Subject: **Proposal for seeking prior approval of the Central Government under FCA, 1980 for non forestry user of 211.8427 hectare of forest land for the construction of Dugar 500 MW Hydro Electric Project in favour of NHPC, under Pangti Forest Division Distt. Chamba Himachal Pradesh. (Online No. FP/HP/HYD/123533/2021).**

Kindly refer to GoI, MOEF and CC letter No. 8-15/2022-FC dated 26.06.2023 on the subject cited above.

2. The point wise observation raised vide above referred communication is attended as under:-

Figure 10.10: Layout of Muck Disposal area

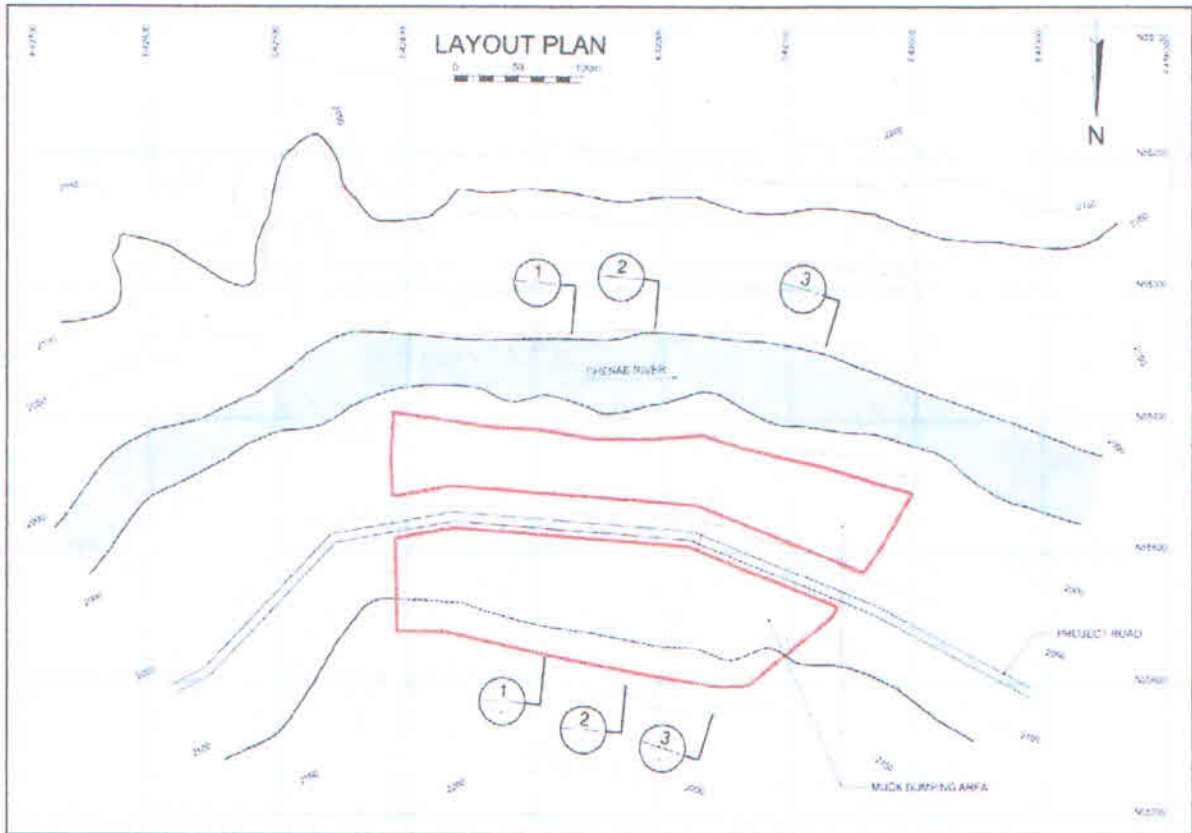
vii. The Muck dumping (8.5797 ha) and the job facility area (7 ha) can be taken on non-forest land. The justification for proposing the same on Forest land may be submitted.

Reply: Muck dumping site involves 8.5797 ha forest land and job facility area involve 7.08 ha forest land as per requirement of the Project. The total land required for the construction of project is 220.62 ha. Out of which 211.84 ha is Forest land and the remaining 8.78 ha is Non-Forest land. As per requirement, a single patch of 8.5797 ha forest land has been identified and found suitable for temporarily disposal of muck, and 7.08 ha forest land has been identified and found suitable for temporarily job facility area (like batching plant, pre-fabrication yard etc). Both the temporarily muck dumping site and job facility area will be handed over back to the State Forest Department after completion of construction activities. After the completion of dumping activity, proper restoration plan with Biological and Engineering measures will be implemented for restoration of the dumping area. A suitable restoration plan has been proposed under the EMP for muck dumping site (copy enclosed from page No. 248 to 255). After the completion of work from job facility area, proper restoration plan with Biological and Engineering measures will be implemented for restoration of the job facility area. A suitable restoration plan has also been proposed under the landscaping and restoration plan of EMP Plan.

Keeping the above requirement, one muck disposal site has been identified downstream of the proposed powerhouse with a total area of 8.58 ha and capacity has been worked as 8,75,000 cum which is much more than the total quantity of muck to be disposed of (refer to **Figure 10.10**).

For stacking of dumped material, concrete reinforced retaining walls are proposed to be built before dumping any material onto the sites (refer to **Figure 10.10**). In addition, leveling would
